### SITE PLAN REVIEW AND APPEARANCE BOARD

### **Delray Beach Club**

Meeting	File No.	Application Type	
June 22, 2022	2022-143-SPI-SPR-CL2	Class II Site Plan Modification

Consideration of a Class II Site Plan Modification for landscape plan modifications and exterior color changes of the building for the existing Delray Beach Club, located at 2001 S. Ocean Boulevard.

# Proposed Building Elevations One of Proposed Building Elevations

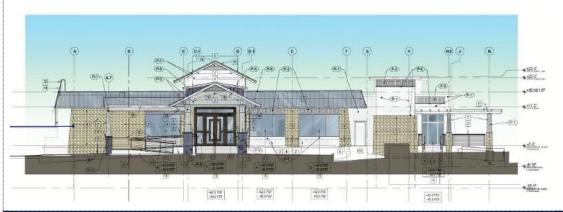
The applicant is requesting approval of a color change for the clubhouse buildings to include:

- "White Diamond" for walls,
- "Cumulus Cloud" for concrete beams,
- "Pure White" for louvers and fascia,
- "Black River Falls" for stucco headers and window sills.

A new standing seam metal roof in a galvalume mill finish is proposed. The existing native coral cladding will remain.

The proposal can be determined to be in conformity with good taste, good design; is not anticipated to cause the local/evolving environment to depreciate in appearance or value; and can be determined to be in harmony with development in the area and the Comprehensive Plan.
